June 28, 2018

**Re: Hydrogeological Reevaluation Report
Spinner Road Crossing (S2-0080)
Permit No. E11-352
Munster Township, Cambria County**

Figure 2. Revised 20-Inch HDD Plan and Profile

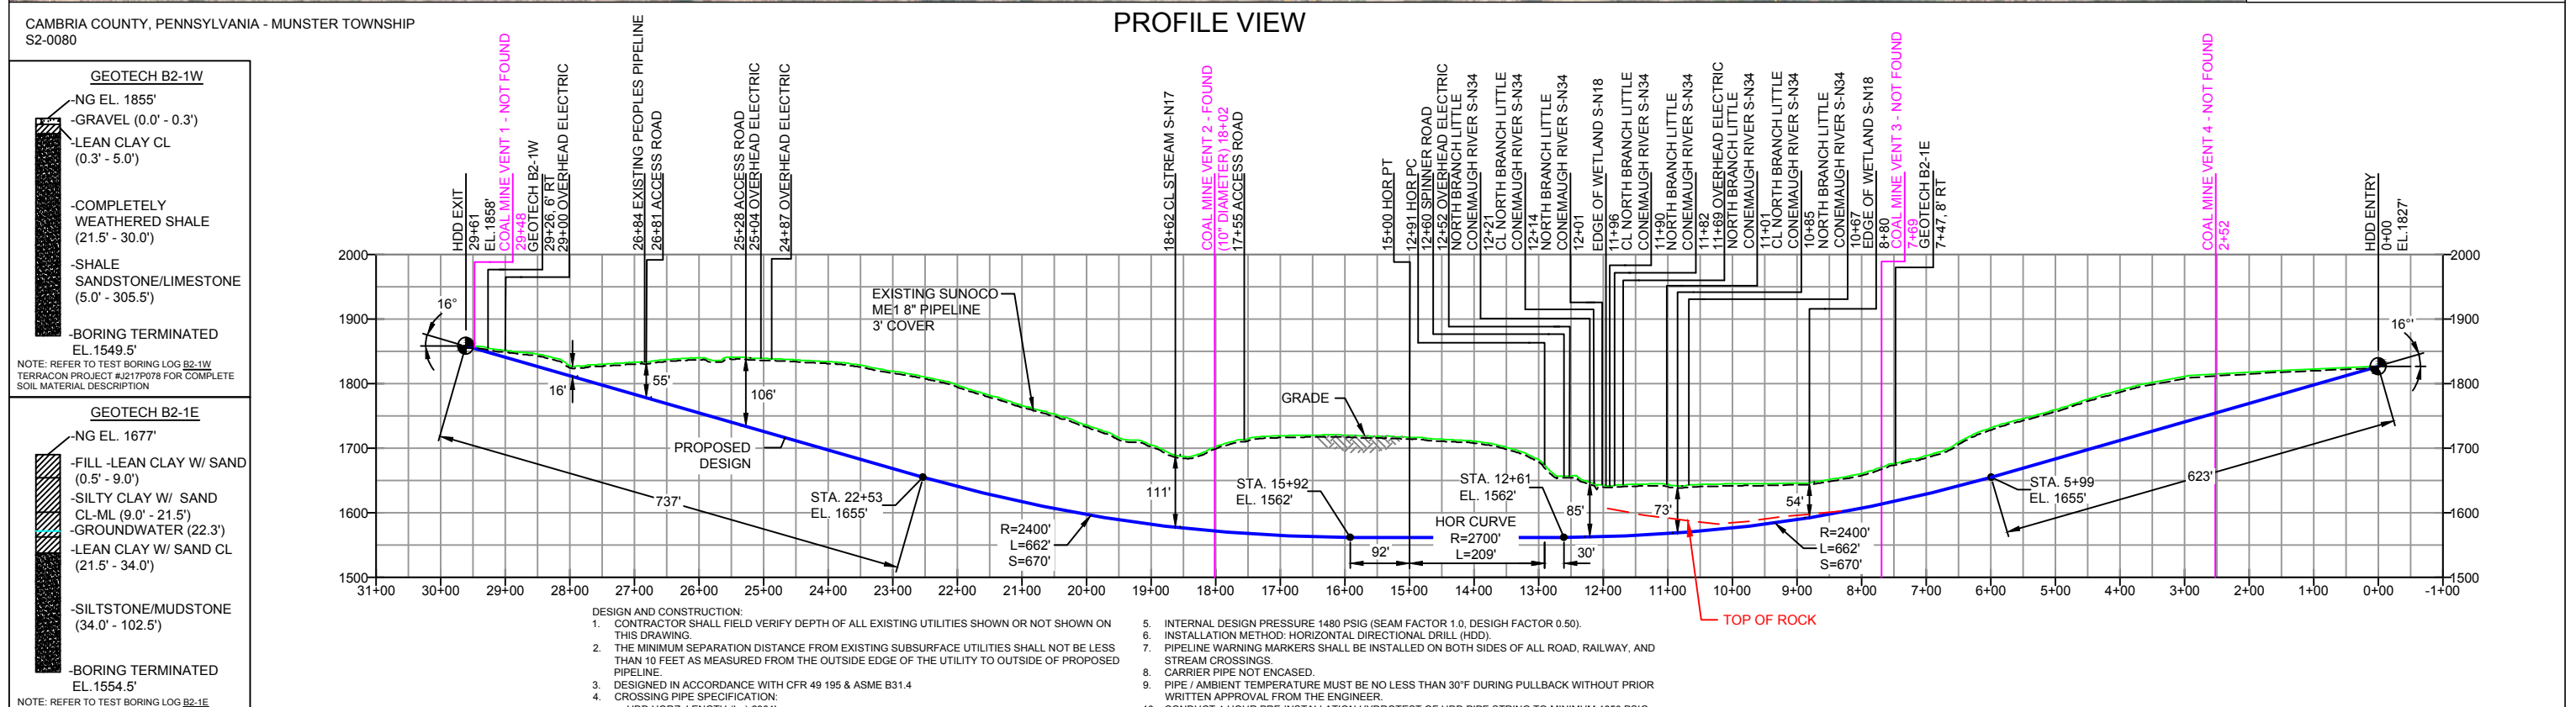
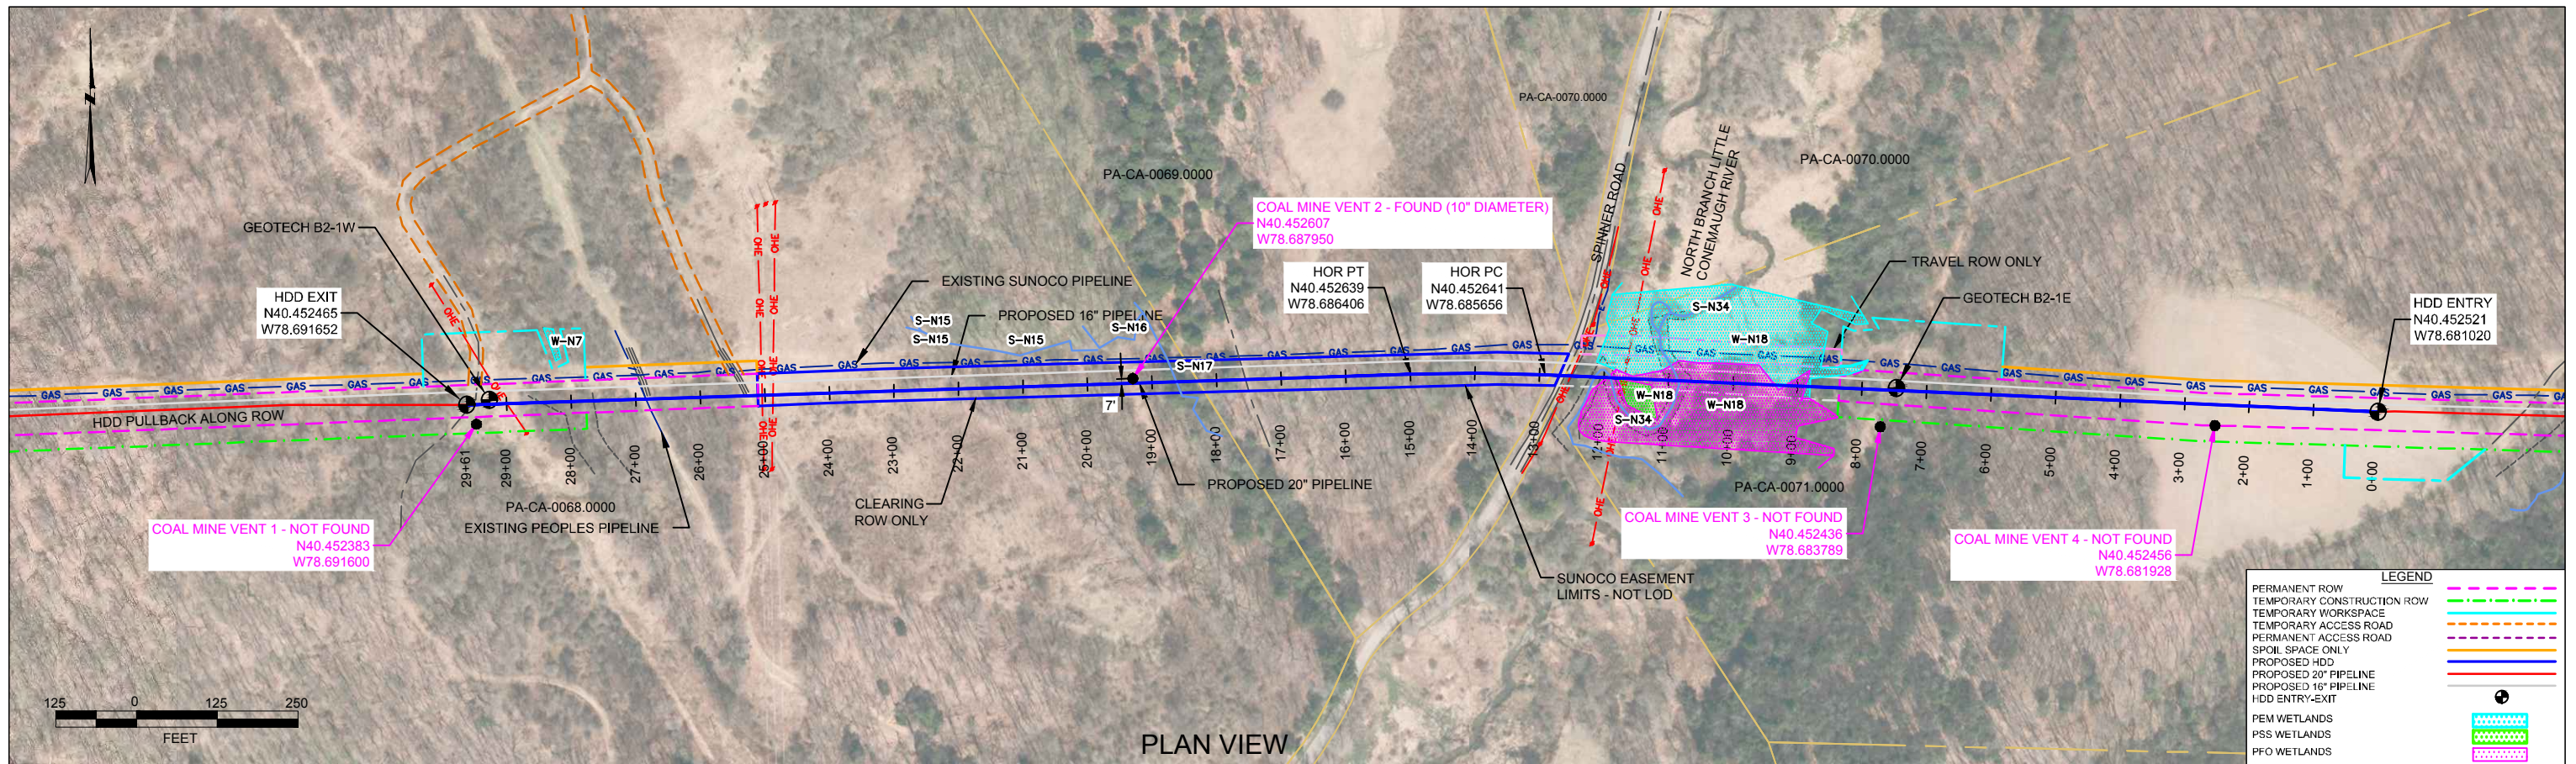
4. Please show the location of the Mariner East 1 pipeline on the profiles.

It is SPLP's intent to modify the original profile design and to pursue a deeper and longer HDD profile. Figure 1 and 3 in Attachment 4 presents the original HDD plan and profiles. Figure 2 and 4 present the revised HDD plan and profiles.

The HDD plan and profiles provided with the Reevaluation Report show the location of the Mariner East 1 pipeline in the "plan view" as being north of and parallel to the planned 20-inch and 16-inch pipeline installations. This pipeline was installed by conventional construction methods, and at the scale of the HDD plan and profiles cannot be shown with accuracy in the profile view. Regardless, a mock representation of the Mariner East 1 pipeline has been added to these profiles and is included with the amended Reevaluation package.
